DEVELOPMENT REVIEW COMMITTEE (DRC) COMMENT REPORT

PROJECT NAME: Bayshore Hotel

CASE NUMBER: R18058

REQUEST: Site Plan Level IV Review: 115 Multifamily Residential Units, 168 Room Hotel, 8,406 SF Restaurant Use, and 3,663 SF Retail Use

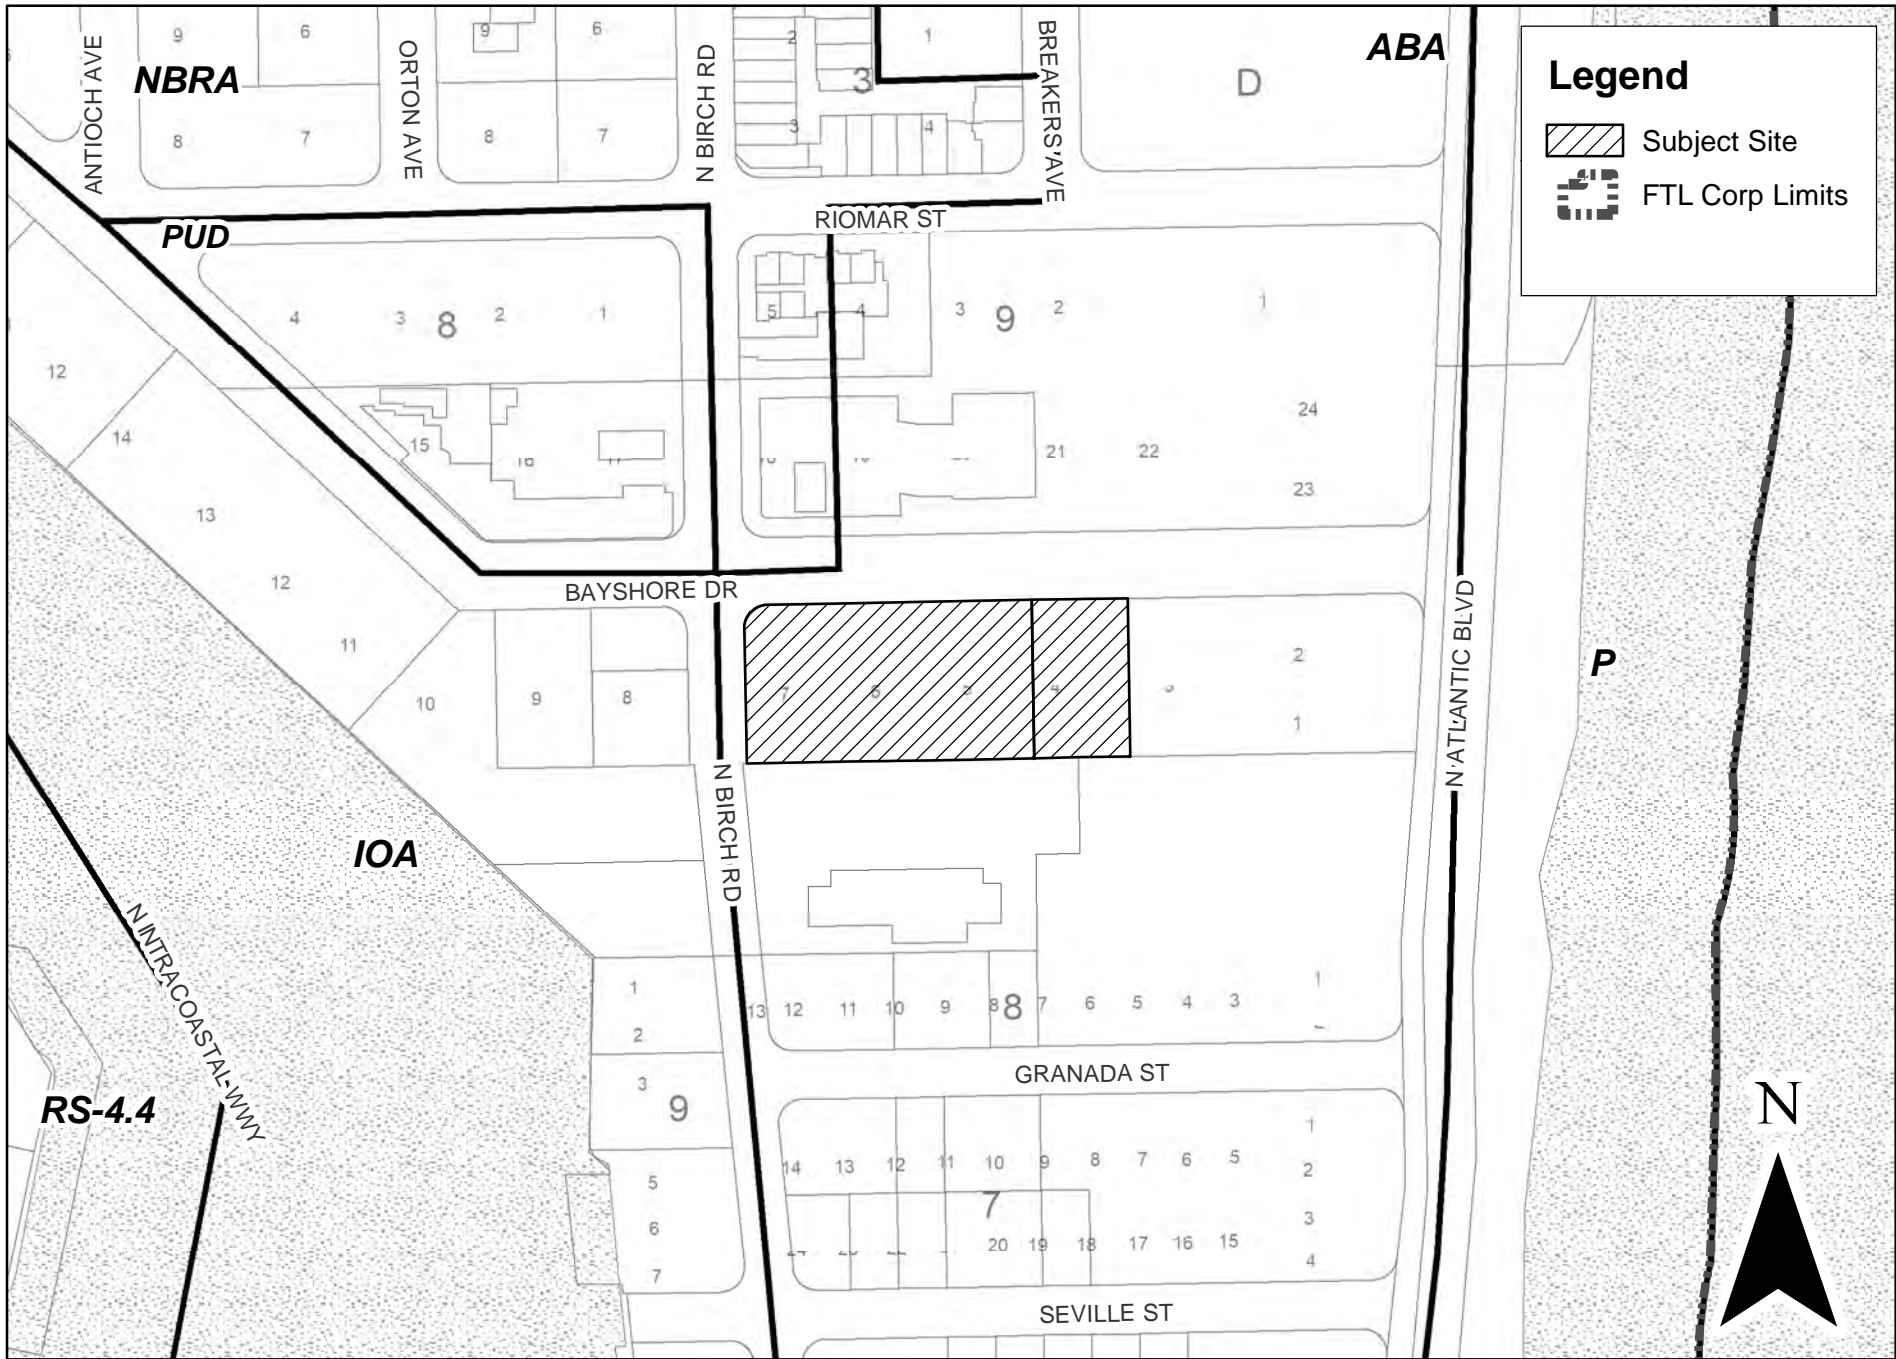
- a. **Provide context elevations** (north/south and east/west) indicating proposed project and nearby properties, including those across adjacent streets and/or waterways. Dimension the height, length, and width of all structures, setbacks, drive isles, landscaping, etc. in order to ascertain the relationship

the proposed development will have on the surrounding properties. Include a rendering of the proposed project as it would be viewed from the Las Olas Bridge.
